EXHIBIT D
Circuit Diagram

File	PC1189.DAA
Size	Document Number
8	PC1789-2.SCH
Date	October 9, 1998
Sheet	2 of 2

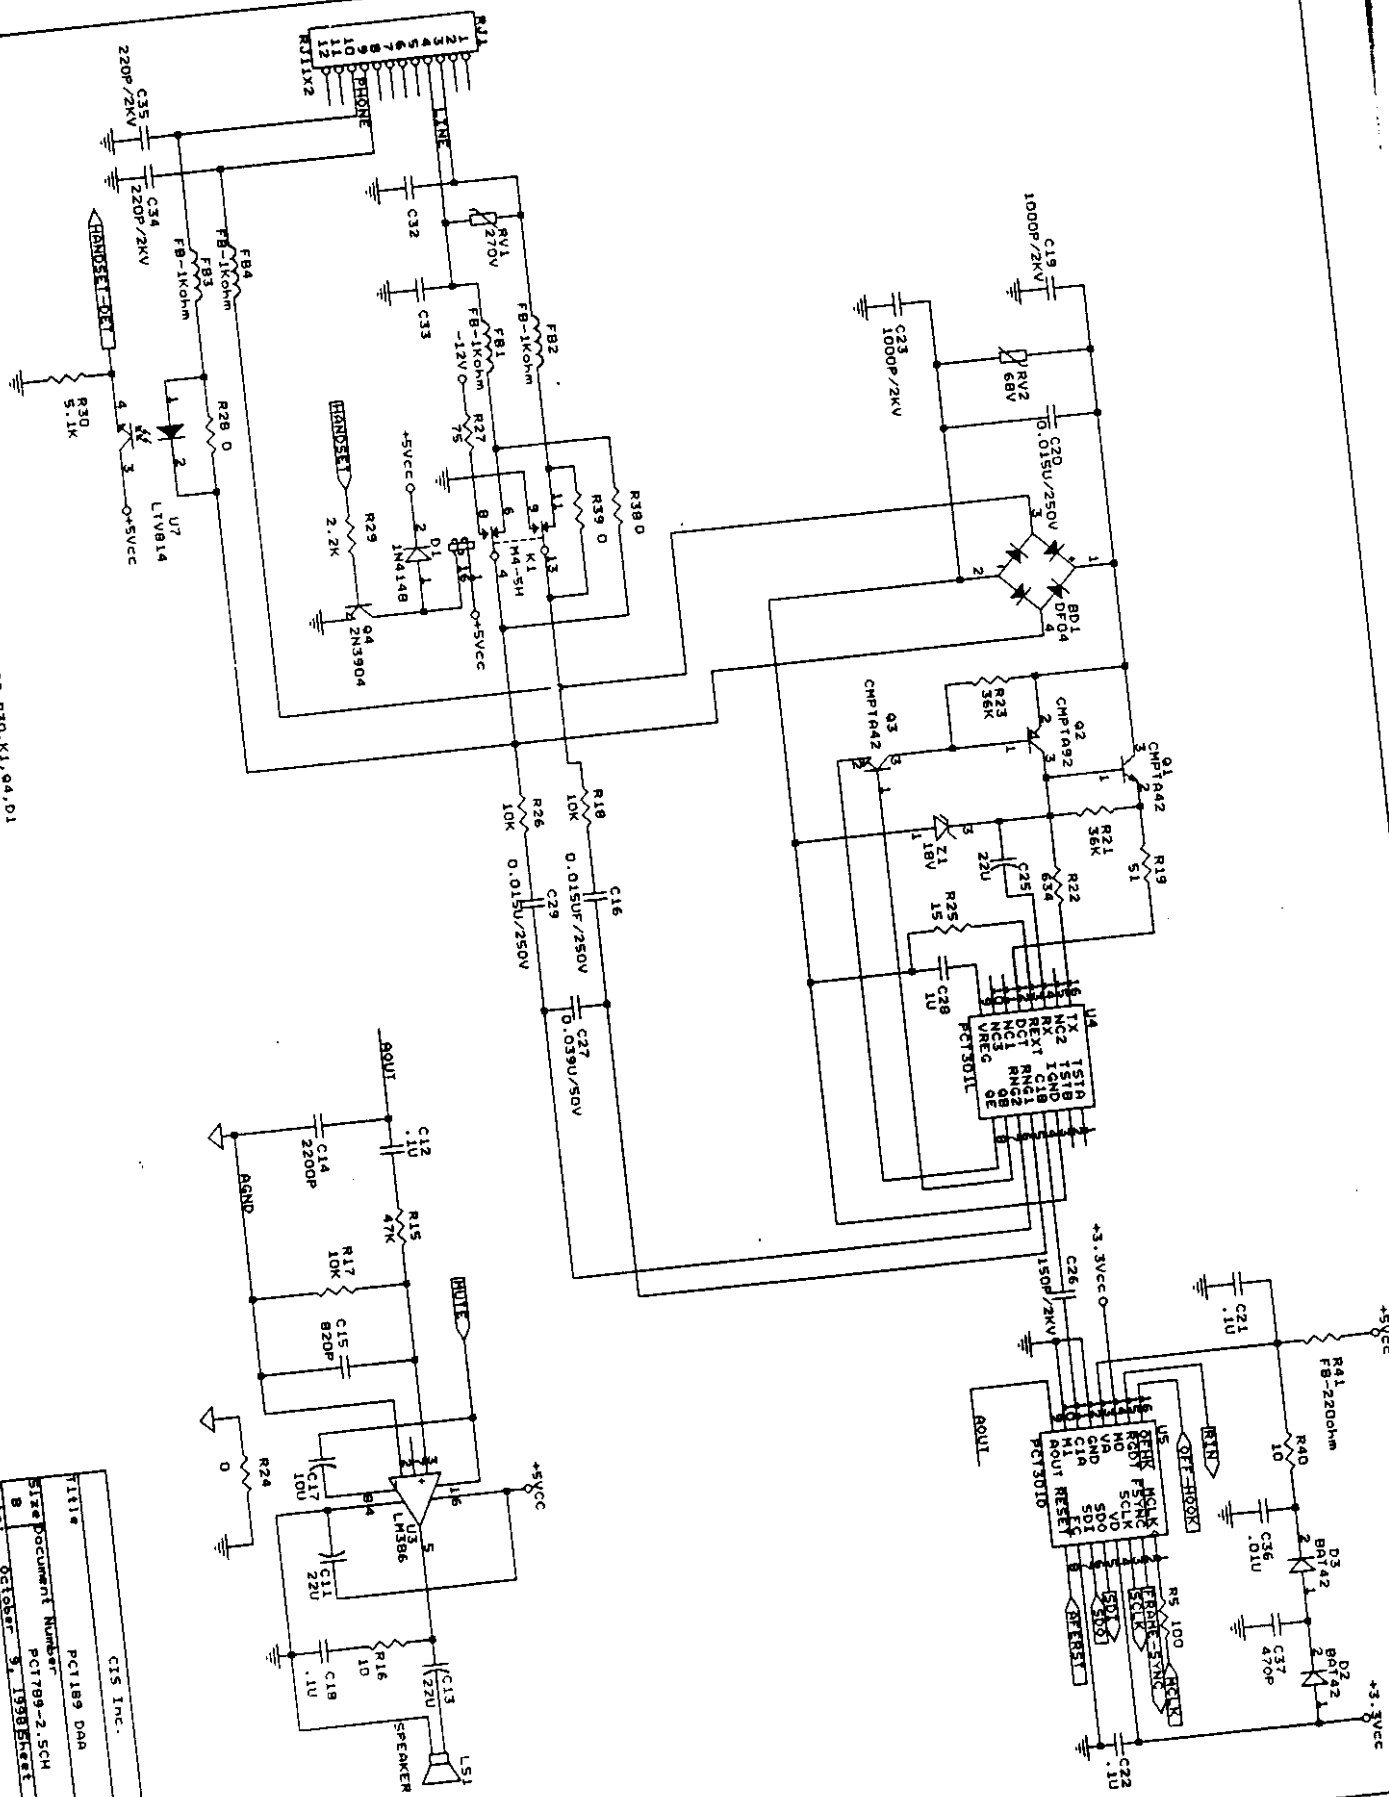
Disable Handset Record & Playback: remove U7, R27, R29, R30, K1, Q4, D1
Install R28, R38, R39
